Product Change Notification

Change Notification #: 112735 - 00
Change Title: Intel® Server System R1208BB4DC,
R1208BB4GS9, R1304BB4DC, R1304BB4GS9,
R2208BB4GS9, R2308BB4GC, and
R2312BB4GS9
PCN 112735-00, Product Design
Update System PSU Bracket
Date of Publication: November 20, 2013

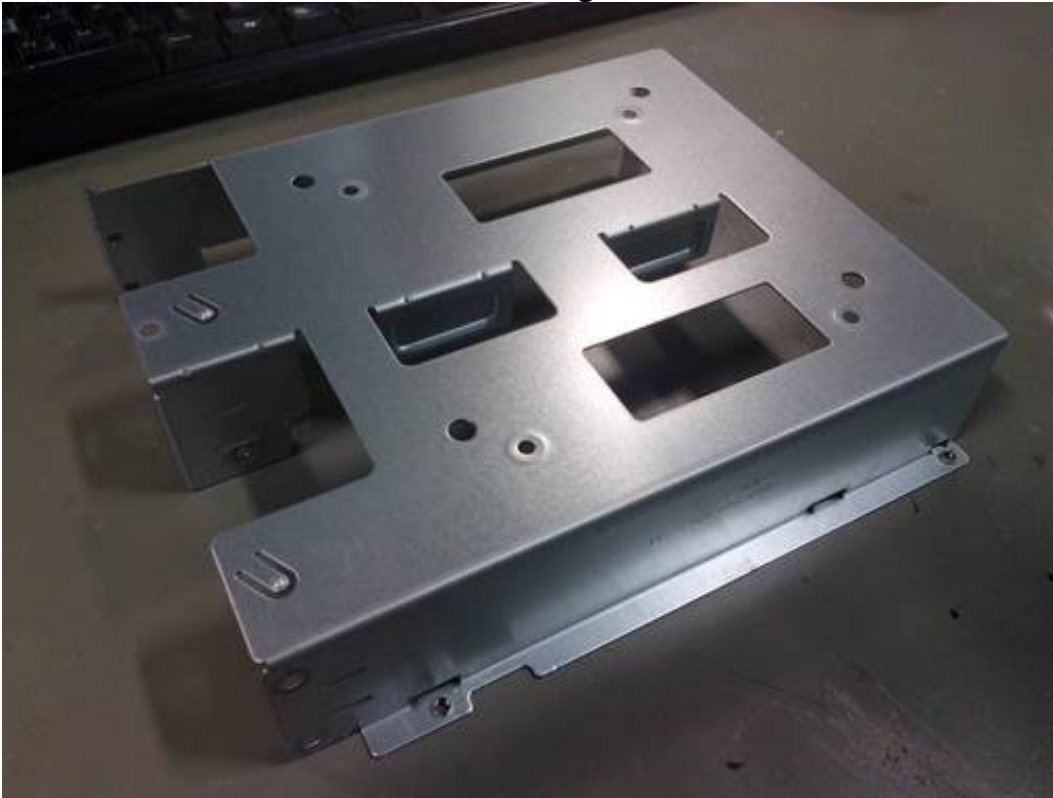
Update the Power Supply bracket to remove middle punch. Please refer to below pictures for details:
